HISTORIC PRESERVATION COMMISSION

STAFF REPORT
Department of Growth Management

MEETING DATE:	October 5, 2016
PROJECT:	12 Lawrence Street – New Construction: Carriage House
APPLICANT:	Tyler Melnik
PROJECT MANAGER:	Erin Schumacher, AICP, Senior Planner

PLAN REVIEW COMMENTS FOR COFA-08-16-009995

A FOUNDATION SURVEY ON PARCEL 176 LAWRENCE STREET, DISTRICT 610, TAX MAP 39A, TOWN OF BLUFFTON, BEAUFORT COUNTY, SOUTH CAROLINA.

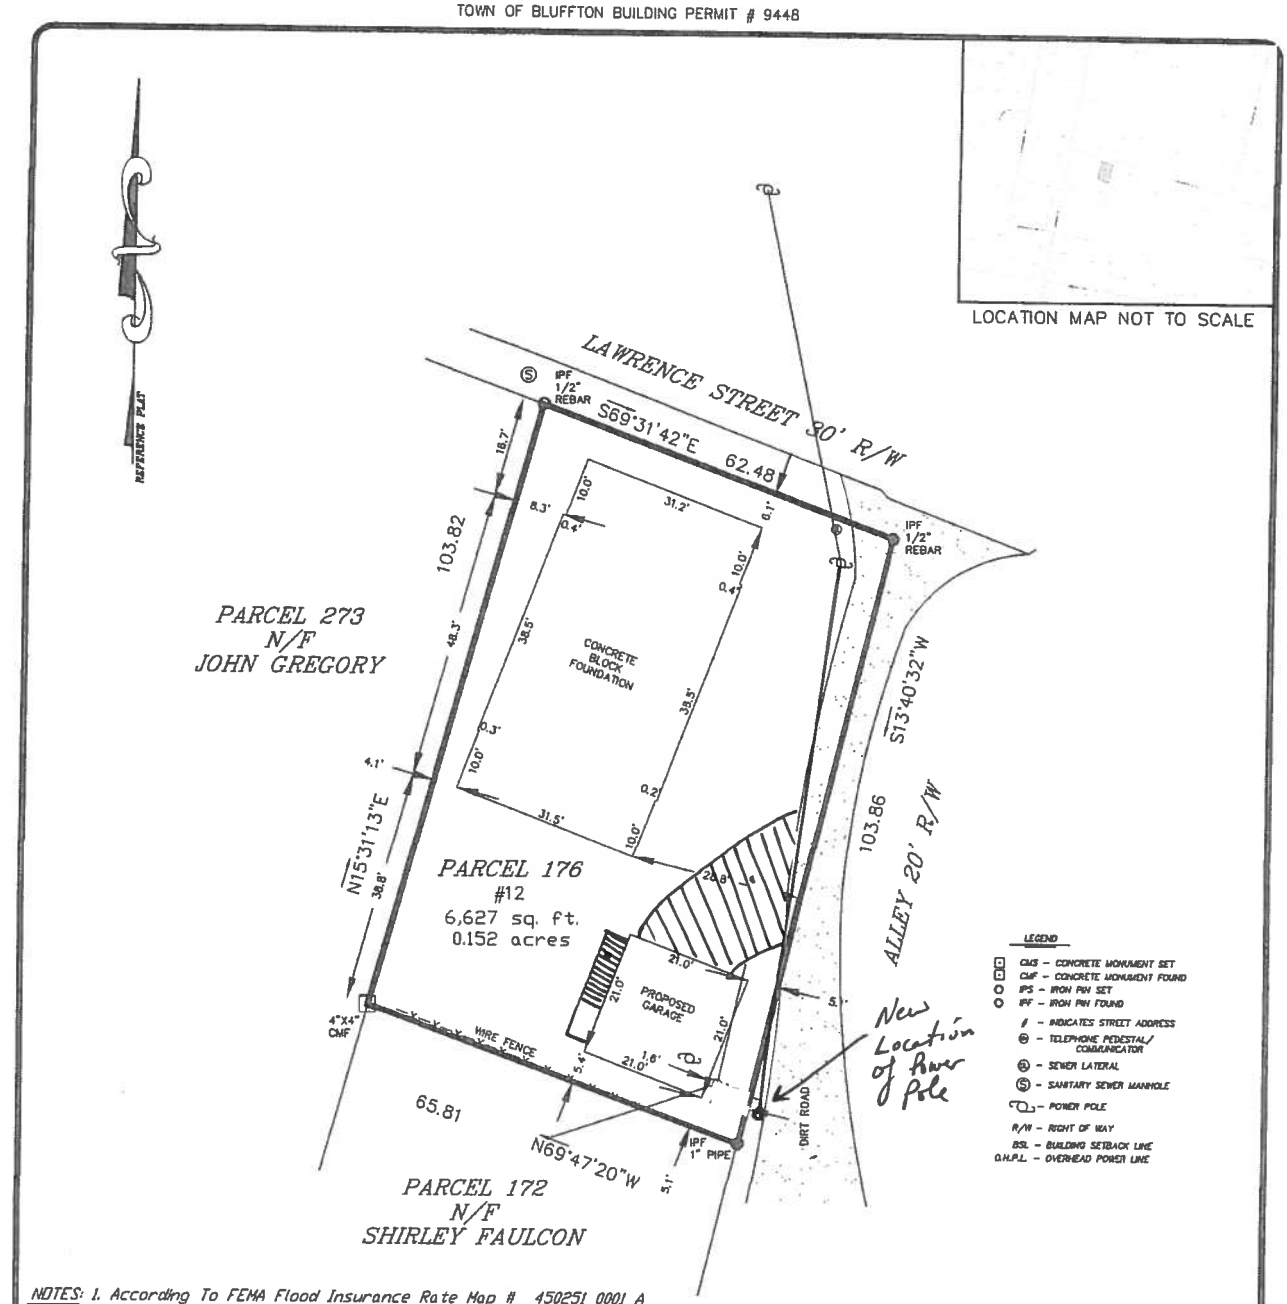
1. Indicate on the site plan the location of the driveway and the full building footprint, including the location of the stair so that it may be reviewed for conformance with setback requirements. (Applications Manual).
2. Consider using the same metal roofing material proposed on the main house for consistency. The plans note the use of asphalt shingle while the project analysis states metal. Clarify the proposed roof material. (UDO Section 5.15.6.J. and 5.15.8.F.)
3. While not required, consider adding shutters to promote better architectural cohesiveness between the character of the main house and the carriage house. (UDO Section 5.15.8.F.)

1. Based on the site plan submitted the existing over head power line is hanging over the building. Either the building or the power line must be move to an appropriate distance.

1. The overhead power line may be a clearance issue for a two story structure. We can take a closer look at this with the building permit application.
2. The projections from the roof will have to be rated due to their being closer than 5 feet from the property line.
3. Additional comments are reserved for the permit application plans review.

D1 TYP. GARAGE SECTION

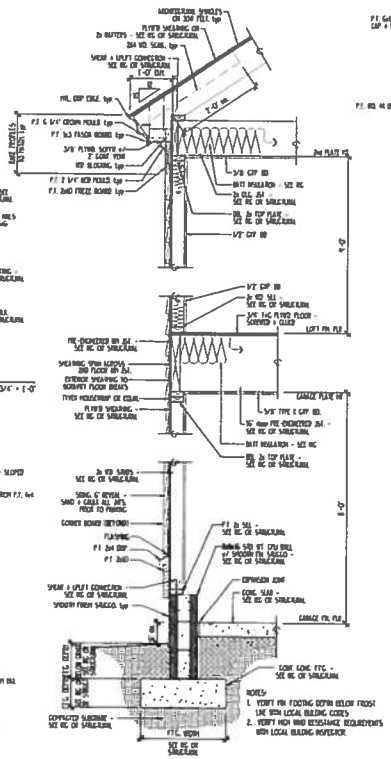
1) Section 5.15.6.P. Cornice, Soffit, and Frieze. The architectural section shows the eave with a closed soffit and notes the use of plywood. The UDO has requirements for the configuration of closed soffits and states that rough sawn wood, plywood, and aluminum are not permitted materials for soffit or cornice detailing. The material must be revised to ensure that it meet the requirements of the UDO.

1. Per Section 5.15.6.P. of the UDO, the architectural section through the eave must be revised to ensure that the soffit materials meet the requirements of the UDO.

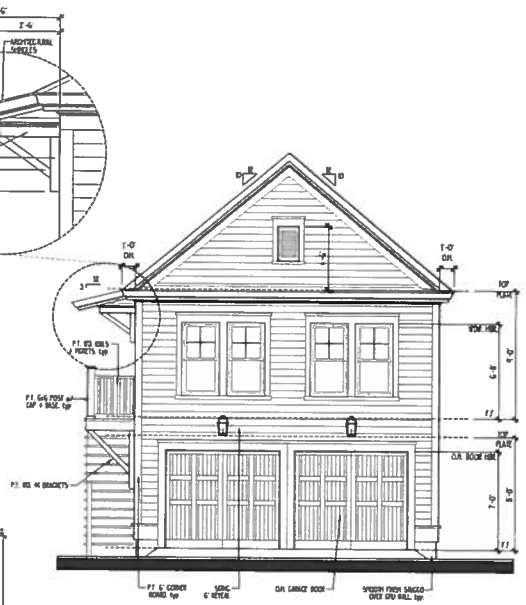
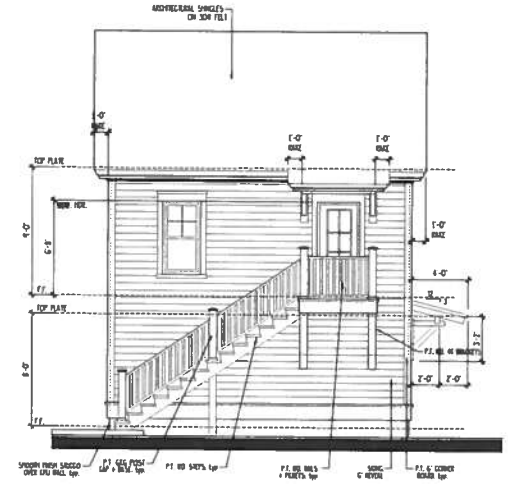
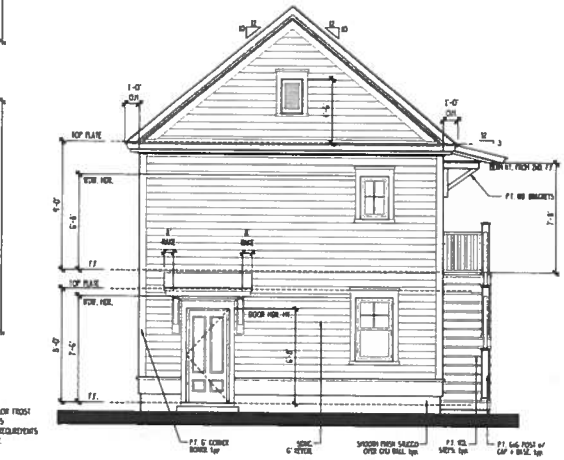
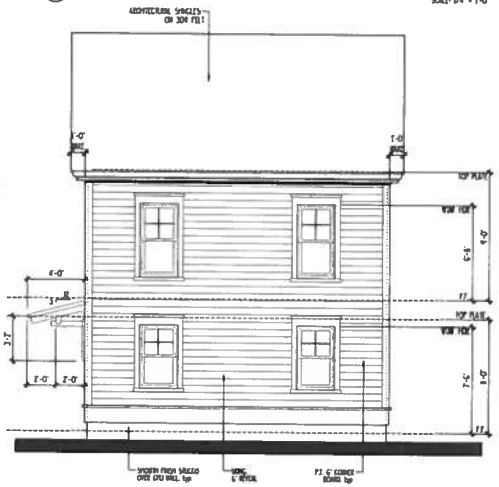
2) Recommendation. The UDO notes that the Carriage House must have the same general character as the primary structure. To provide better cohesiveness between the two structures consider modifying the roof form (i.e. gable to hip) and/or adding shutters.

1. Per Section 5.15.8.F. of the UDO, consider modifying the roof form (i.e. gable to hip) and/or adding shutters to provide better architectural cohesiveness between the two structures.
